WILLIAMSON COUNTY

Addendum #1 to Kitchen Equipment Bid
For Public Safety Facility
RFP Opening Date September 24, 2015

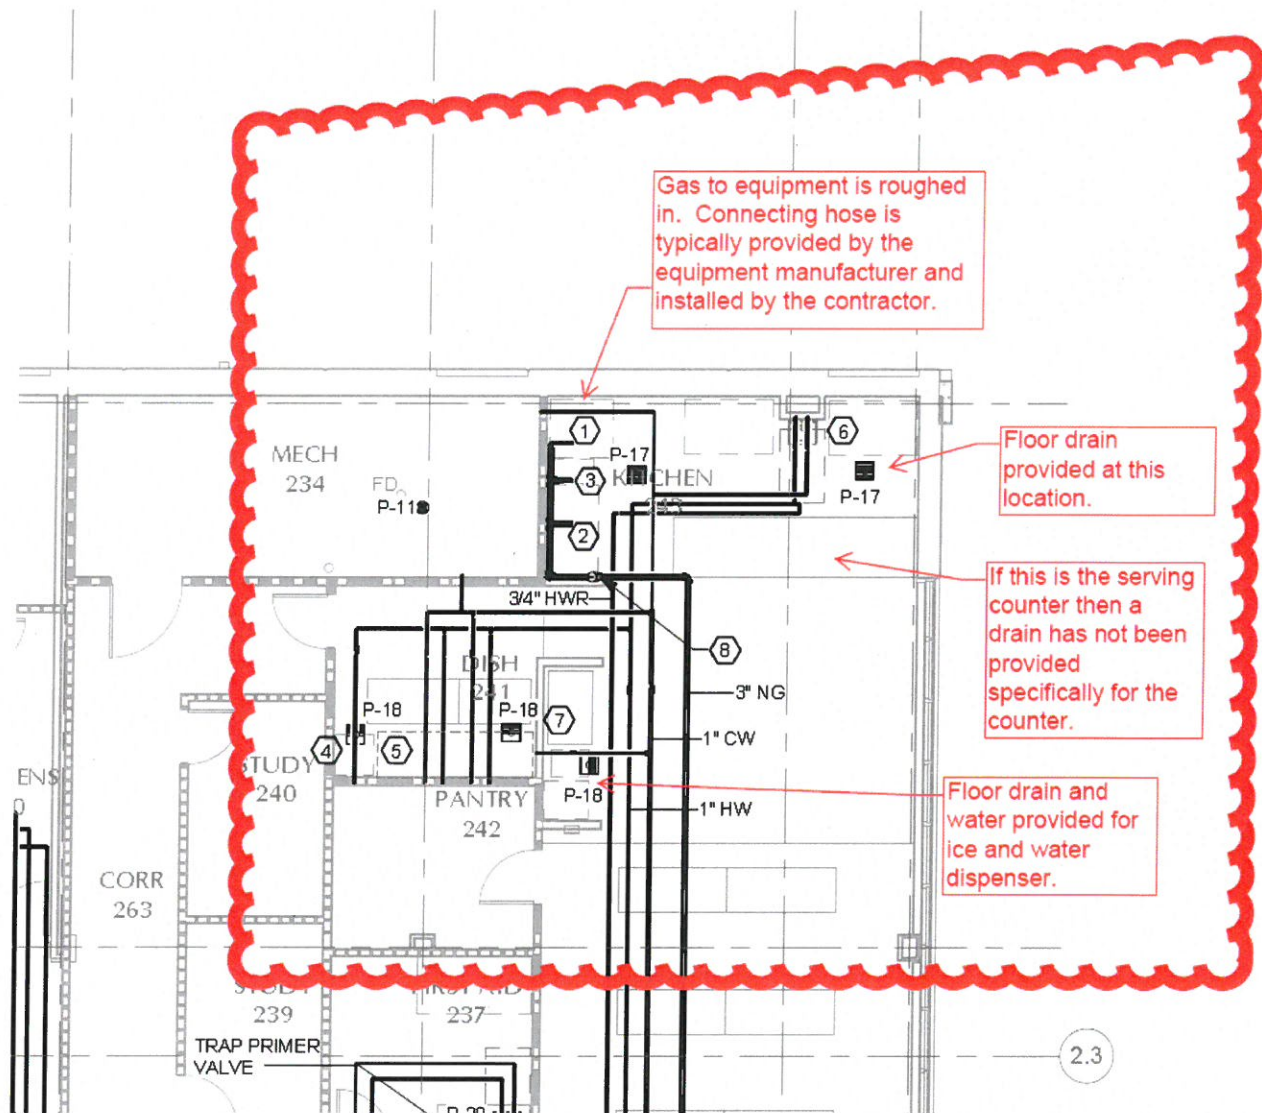
RE: gas equipment, will you be supplying the gas connector hose? If not, what length do you need?

RE: hot and cold food counters, do you have a floor receptacle with the correct NEMA configuration? Is there a floor drain within six feet of the unit, or will you drain into a bucket?

RE: Ice makers, is there electrical connection, water connection and floor drain within six feet of the unit? Will the water filter connect to the ice maker or a wall in close proximity?

The questions are answered on the attached drawings.

RESPONSES TO PLUMBING-RELATED QUESTIONS:

RESPONSES TO ELECTRICAL-RELATED QUESTIONS:

Assuming this is the Hot/Cold food counters, No floor receptacles, and this wall mounted outlet was intended to be used for that. However, we do not know what the correct NEMA configuration is needed, this needs to be coordinated with the electrical contractor.
